ARKANSAS DEPARTMENT OF
POLLUTION CONTROL AND ECOLOGY

MINUTE ORDER NUMBER 82- 40

TO: John Ward, Permits Branch Manager
FROM: Mark Witherspoon, Permits Engineer - Land Disposal Section *mw*
DATE: April 22, 1982
SUBJECT: Arkansas Kraft Corporation at Morrilton request for modification of solid waste permit #S-0176

Re: Arkansas Kraft Solid Waste Permit No. S-0176

WATER THRU SWDA

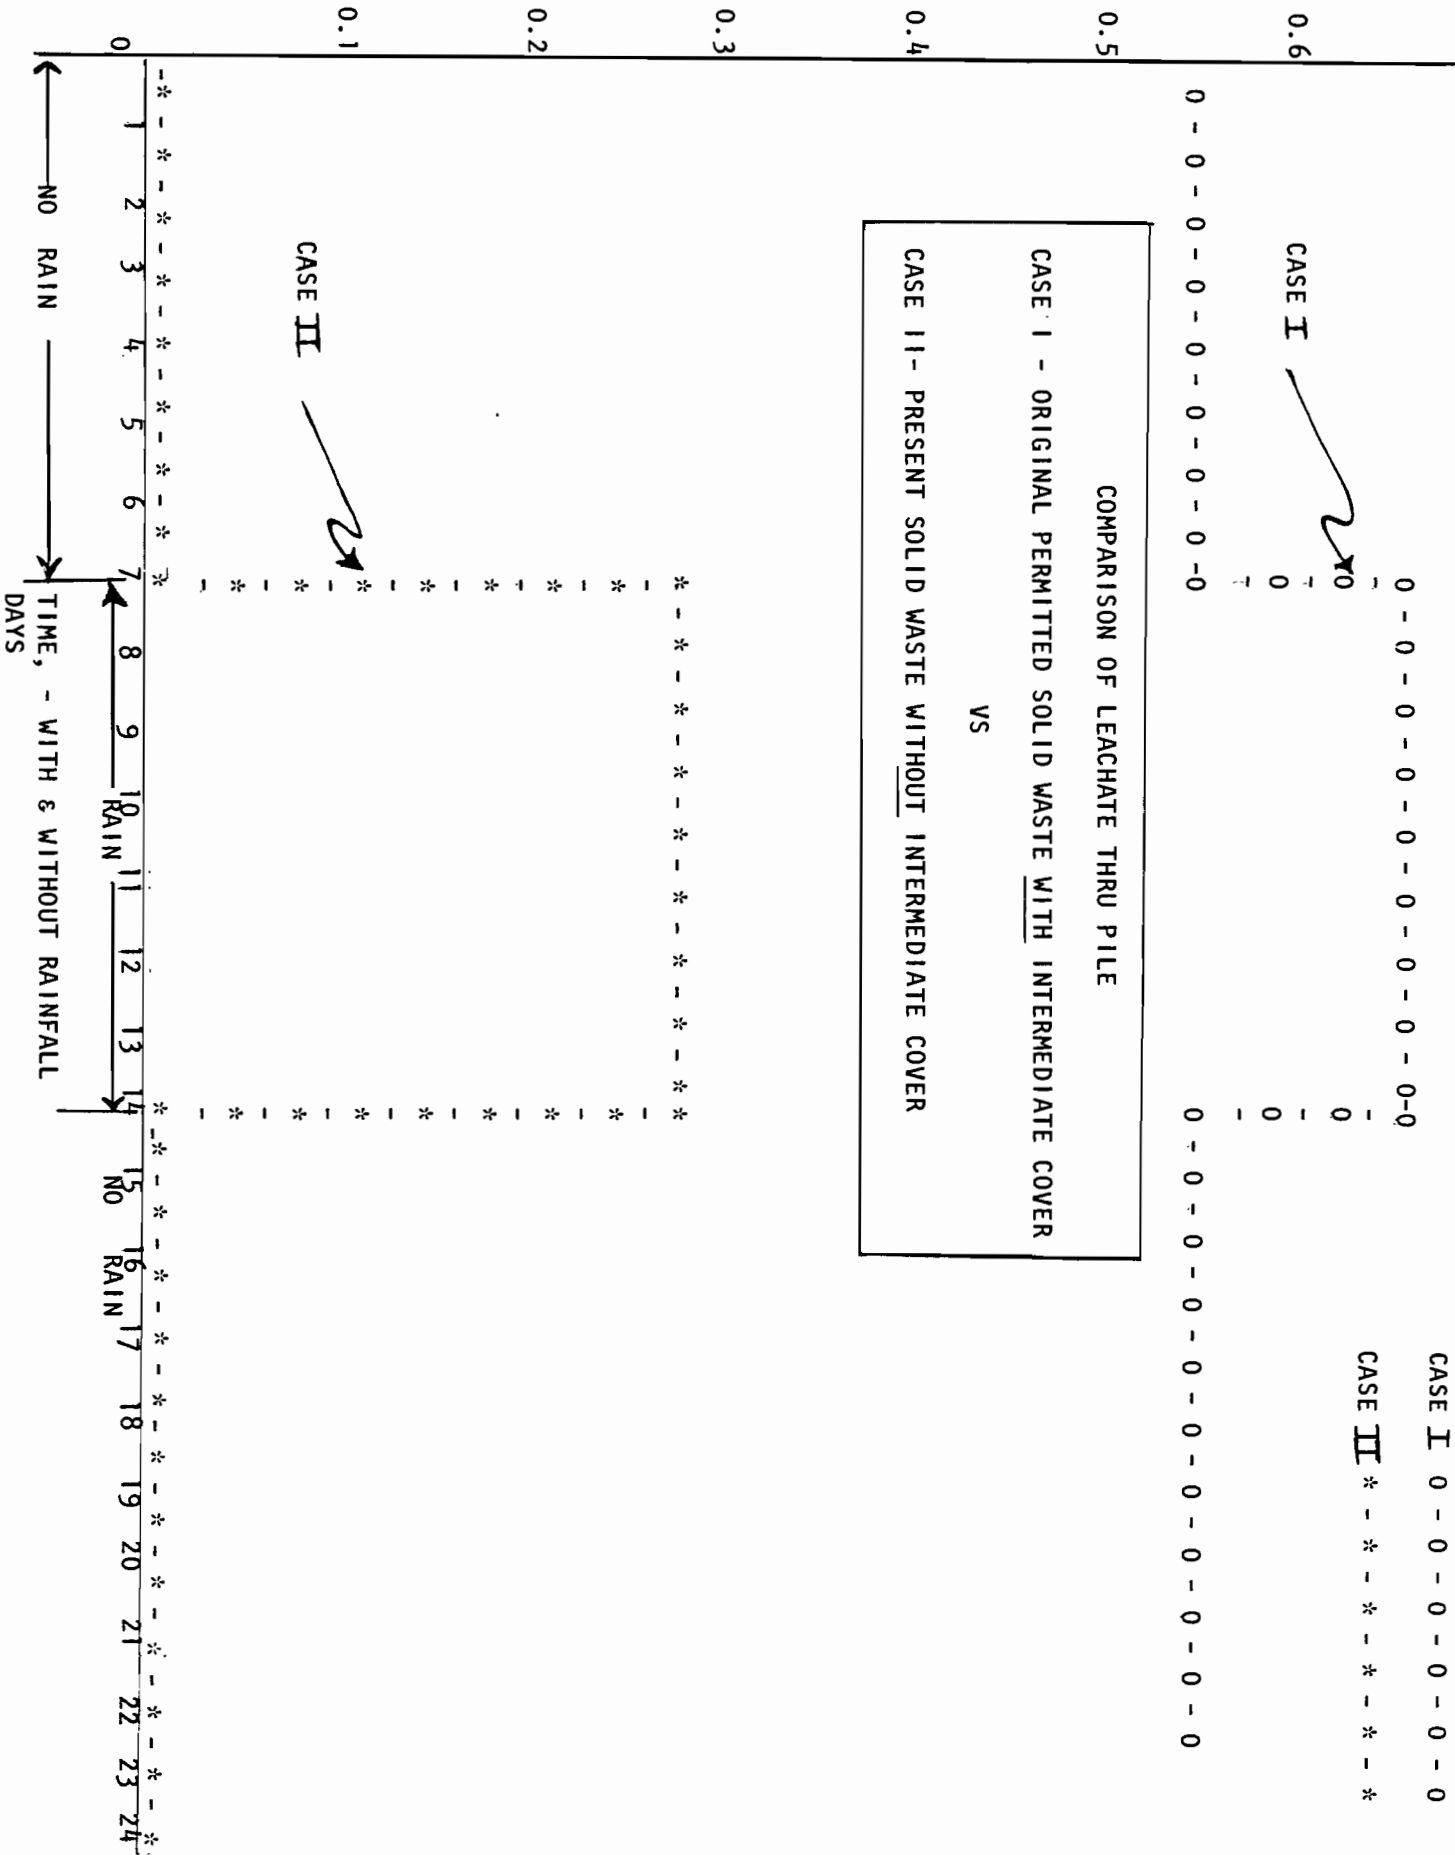
An assessment of the solid waste disposal activity as it exists now as compared to that presented in the original permit is projected as follows (next page); and a graphical representation of the comparison between the two situations is presented on page 3.

The leachate percolating thru the solid waste disposal area (SWDA) is composed of rainfall plus the water in the solid waste streams going to the SWDA.

- A) Assume 10' rainfall in a 7 day period.
- B) Assume the uncovered strip subject to leaching from this rainfall to be;
 - 1) 50' x 100' in the case of the SWDA with the cellular structure (intermediate cover). Case I.
 - 2) 50' x 300' in the case of the SWDA without the cellular structure (final cover only). Case II.

Comparing Case I to Case II, it can be seen that under the present conditions (Case II), we will have less leachate generation, even without intermediate cover, than existed at the time of the original permit with intermediate cover (Case I).

Therefore, the generation or percolation of leachate, including rainwater, in the SWDA should not be a cause for concern.
